In response to your application dated December 10, 1979, supplemented by letters dated February 6 and March 24, 1980, the Commission has issued the enclosed Amendment No. 42 to Facility Operating License No. DPR-25 for Dresden Nuclear Power Station Unit 3.

DRESDEN NUCLEAR POWER STATION UNIT NO. 3

Amendment No. 42  
License No. DPR-25

ATTACHMENT TO LICENSE AMENDMENT NO. 42

FIGURE 3.5-1  
(Sheet 1 of 5)

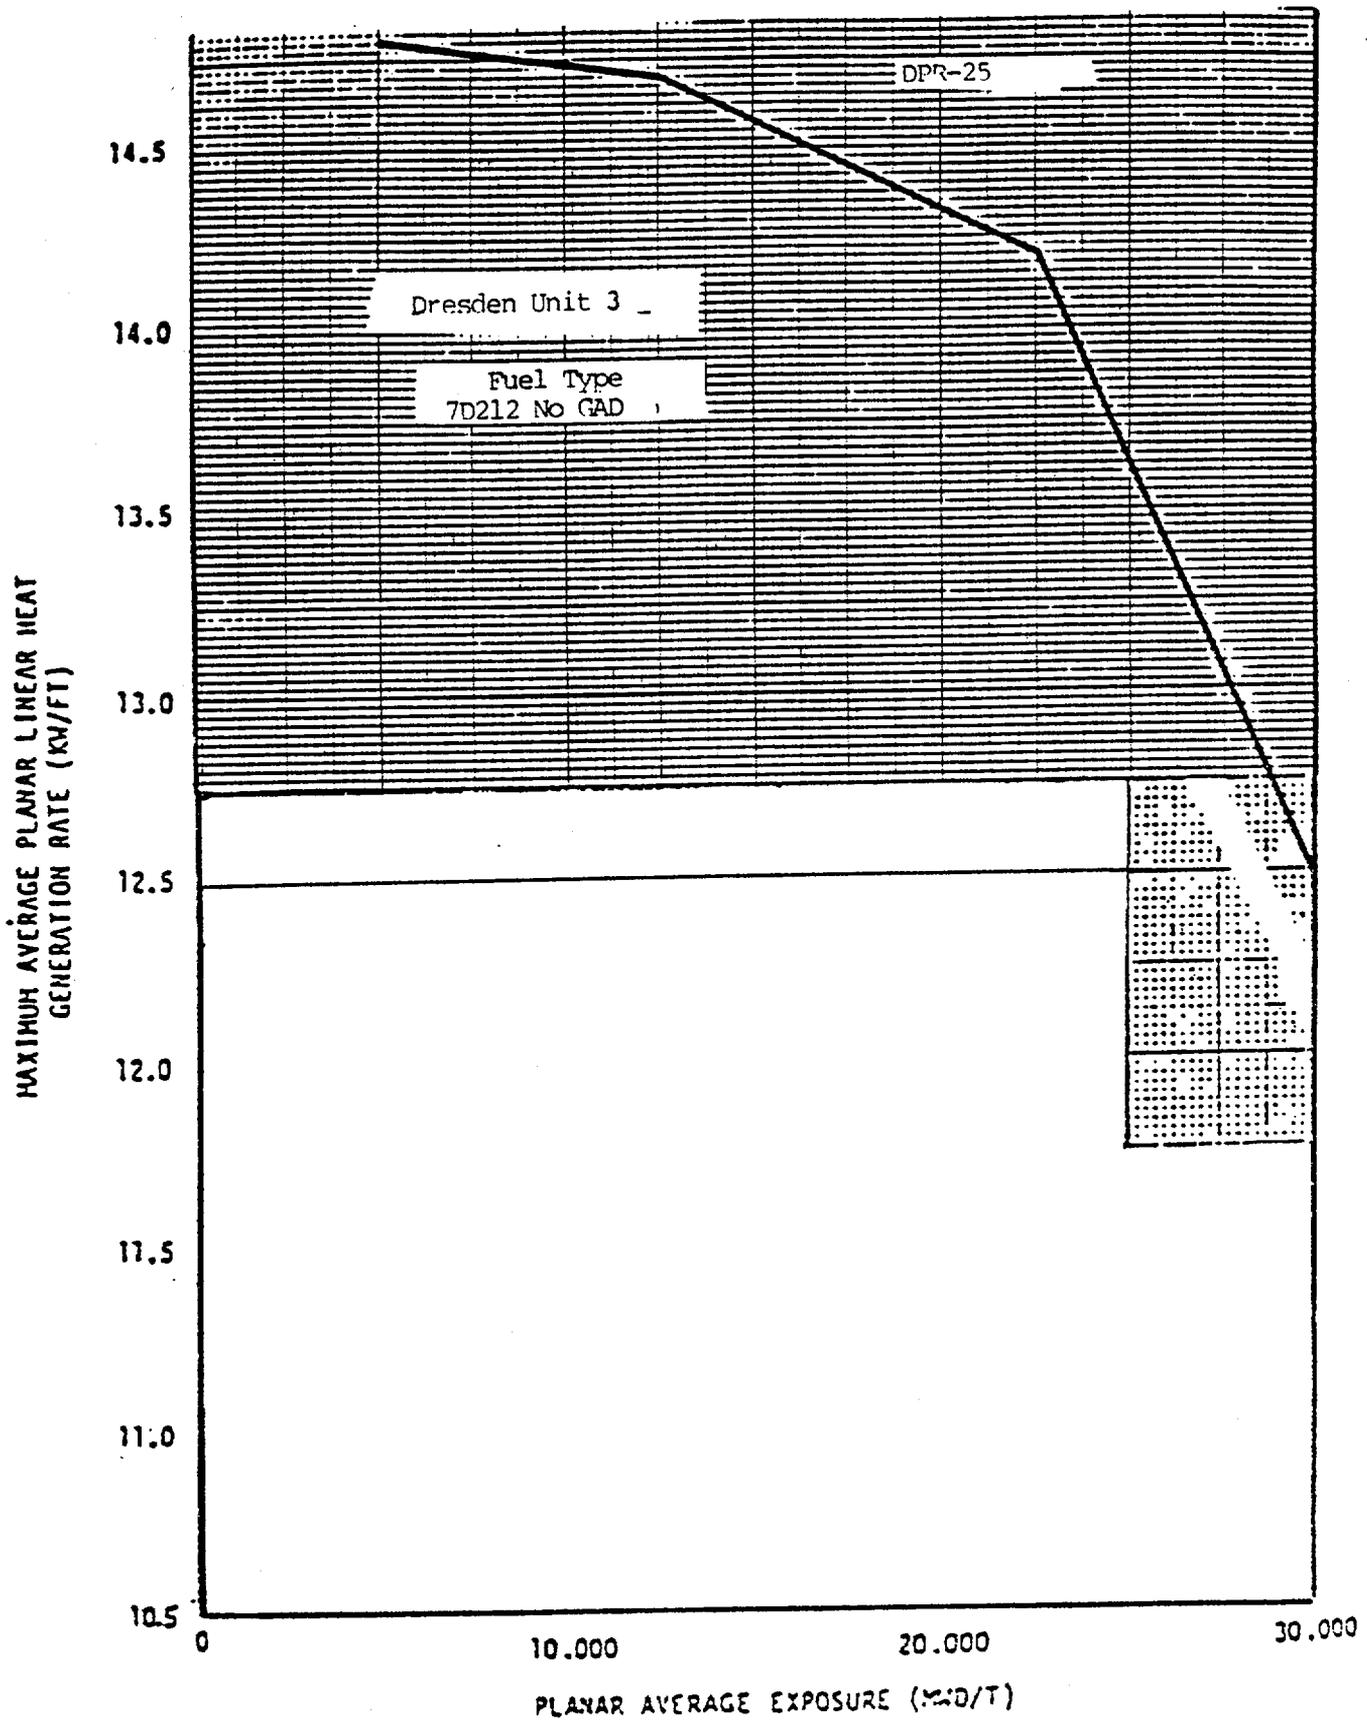
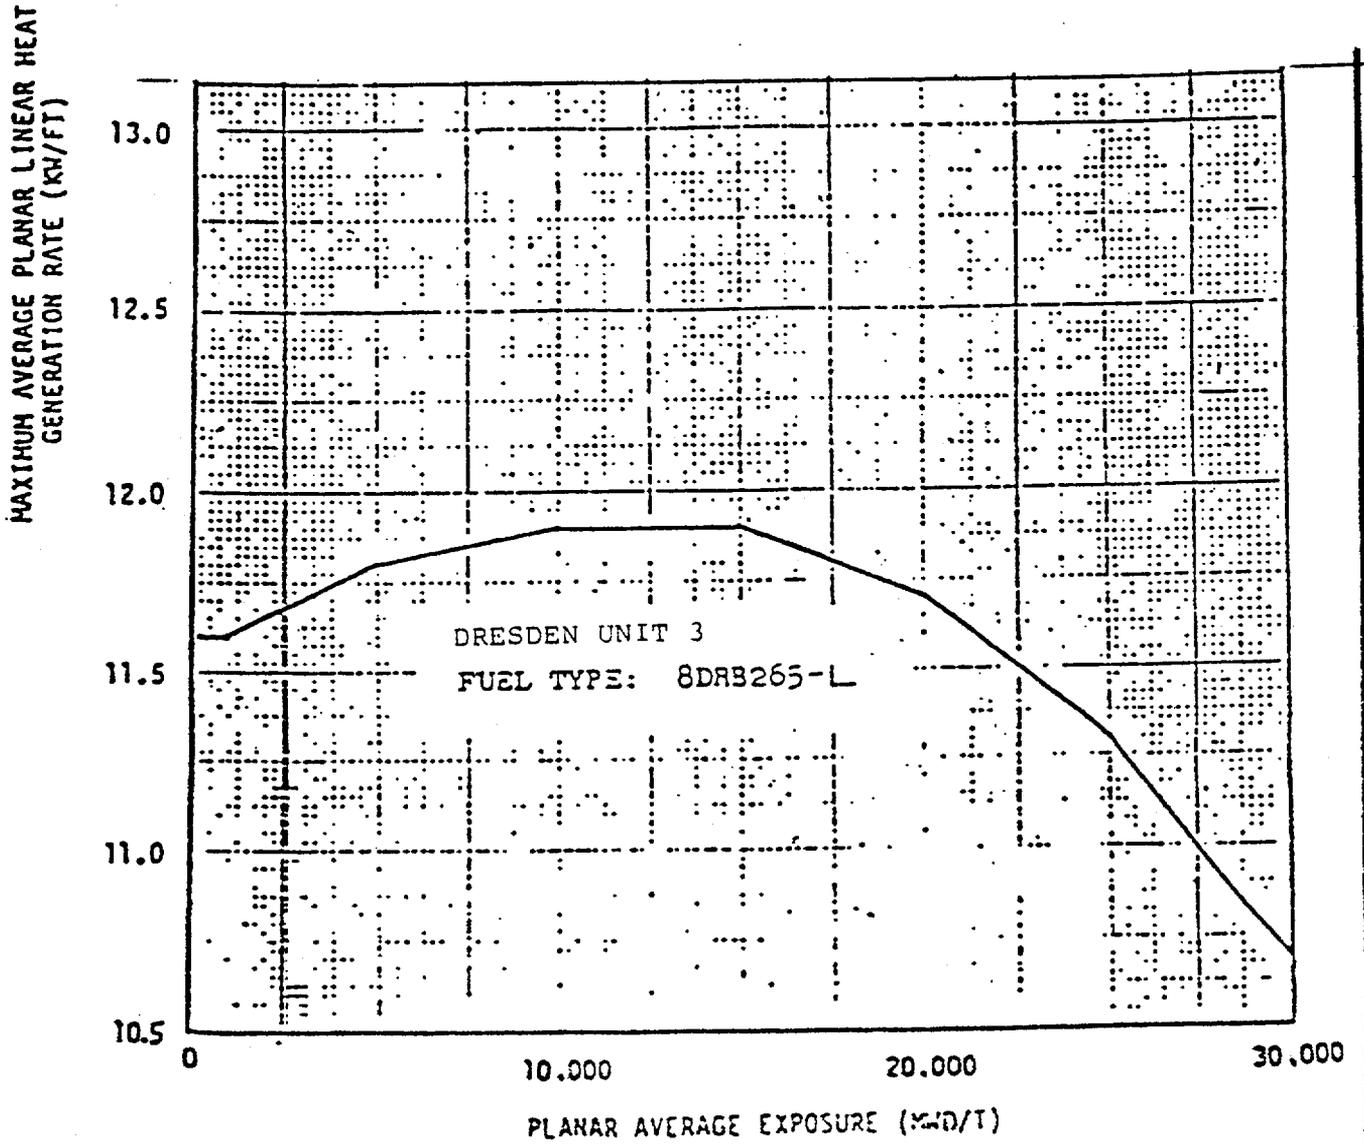
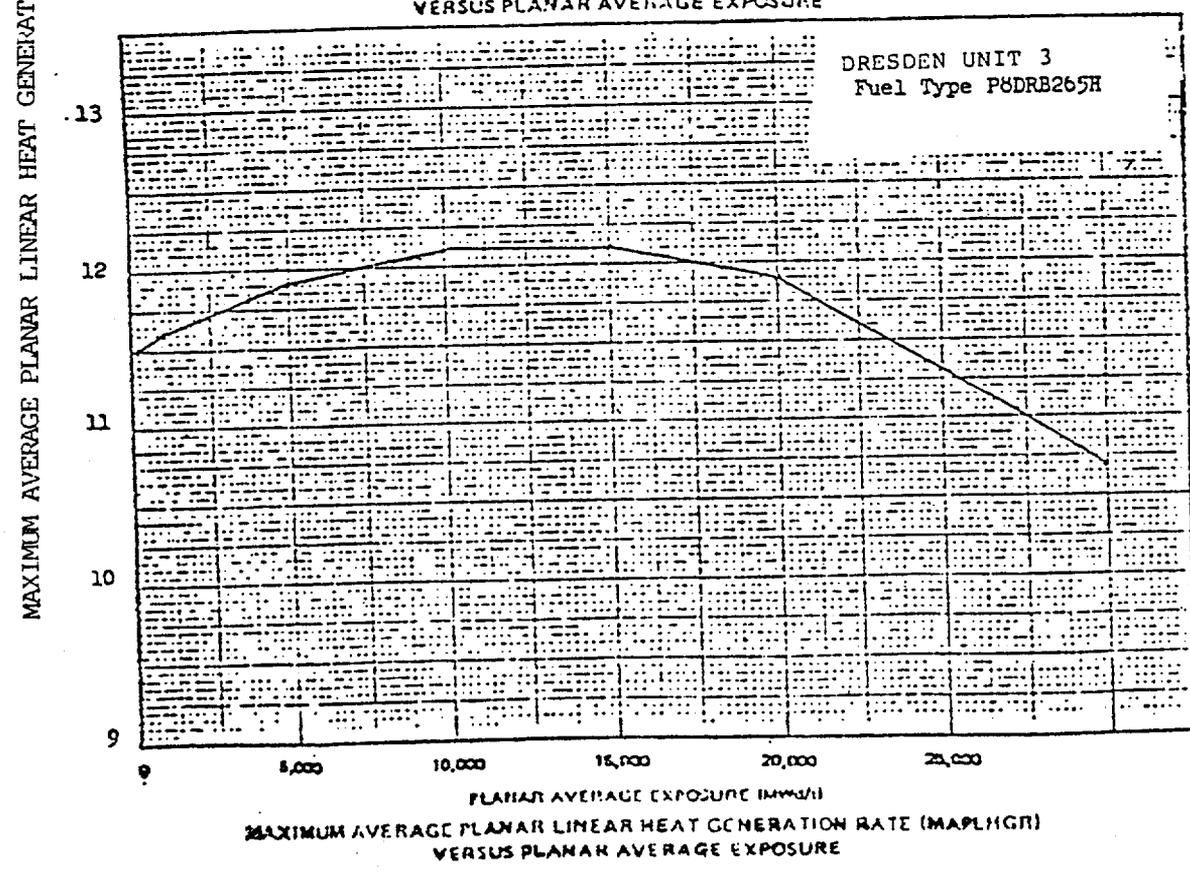
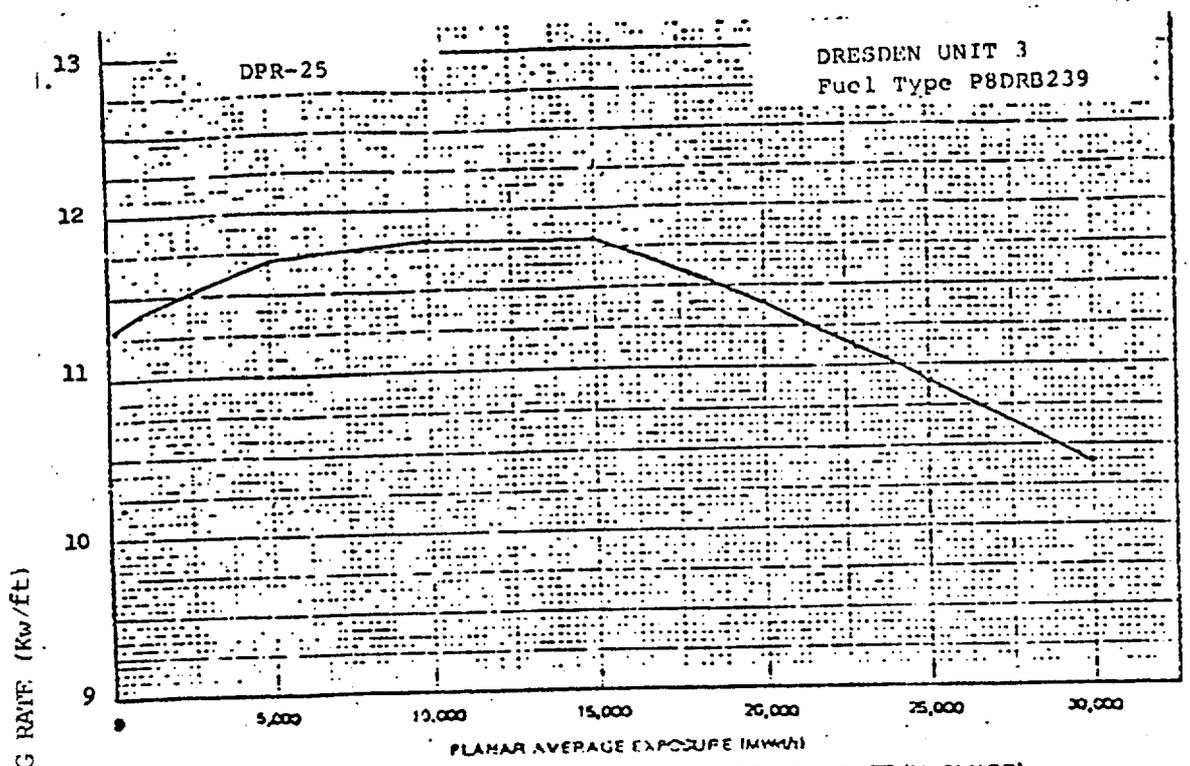
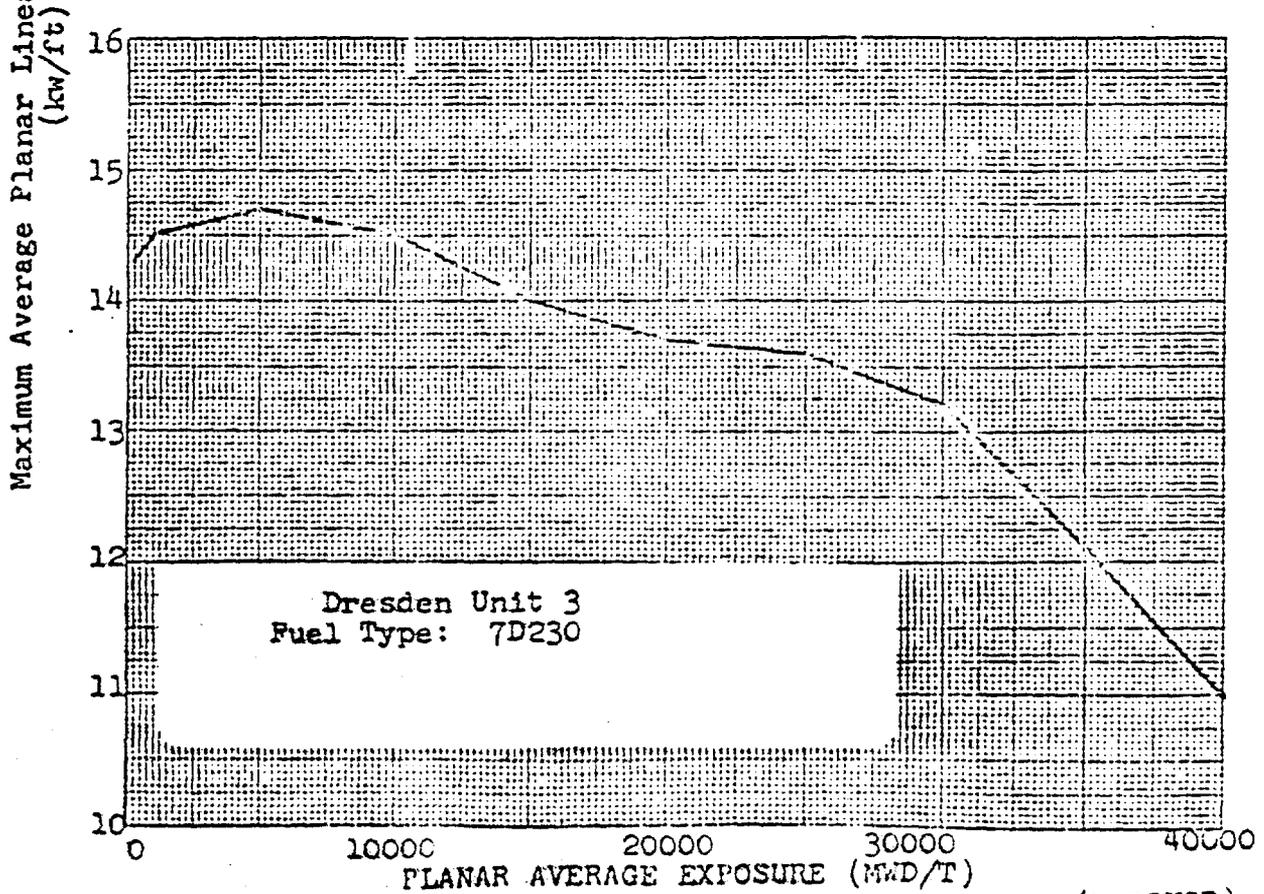
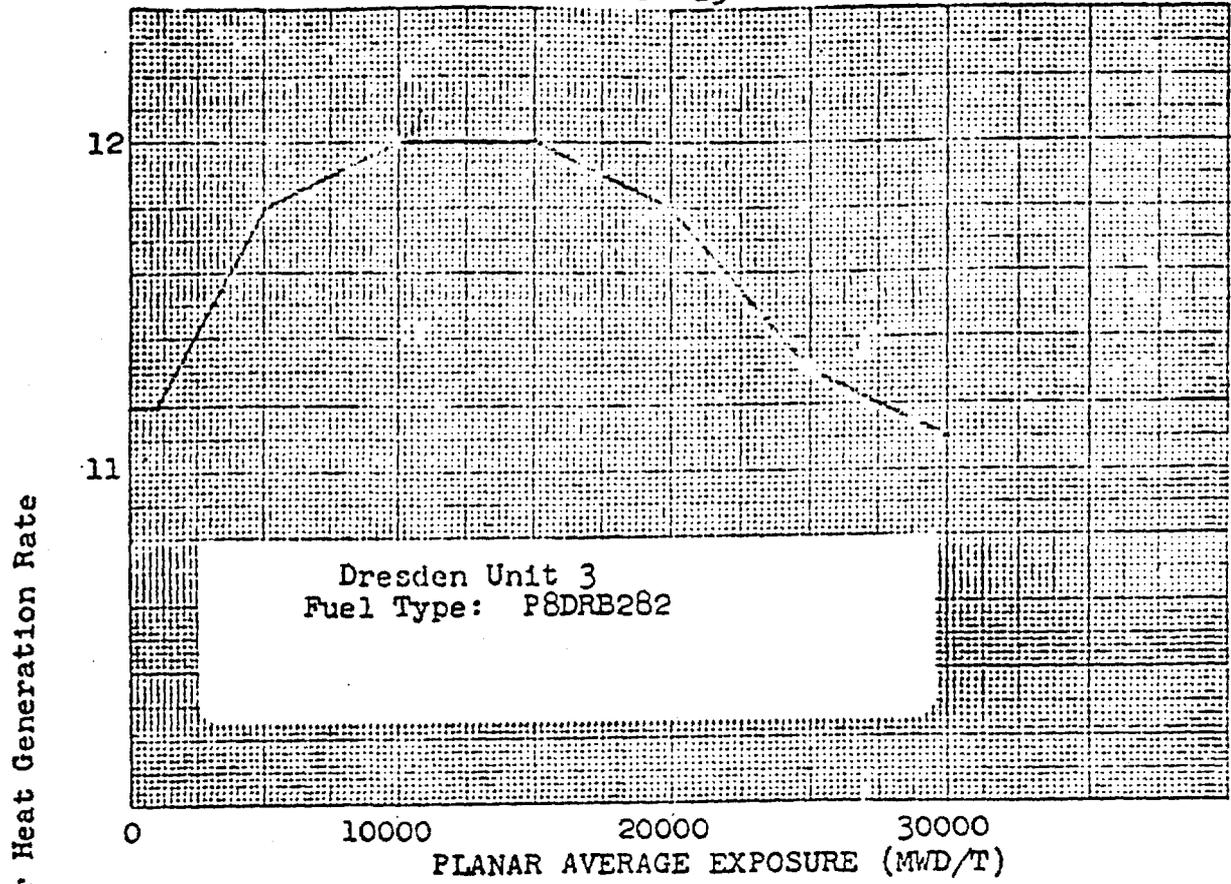
### Maximum Average Planar Linear Heat Generation Rate (MAPLHGR)

The LHGR power spiking penalty for 8x8 fuel has been incorporated in the safety analyses by the reduction of the LHGR limit by an equivalent amount. This change has been generically accepted by our Reference 5 letter.

The maximum average planar ICHG shown in Figure 3.5.1 are based on calculations employing the models described in Reference (1). Power operation with ICHGs at or below those shown in Fig. 3.5.1 assures that the peak cladding temperature following a postulated loss-of-coolant accident will not exceed the 2200°F limit. Those values represent limits for operation to ensure conformance with ICFR50 and Appendix K only if they are more limiting than other design parameters.
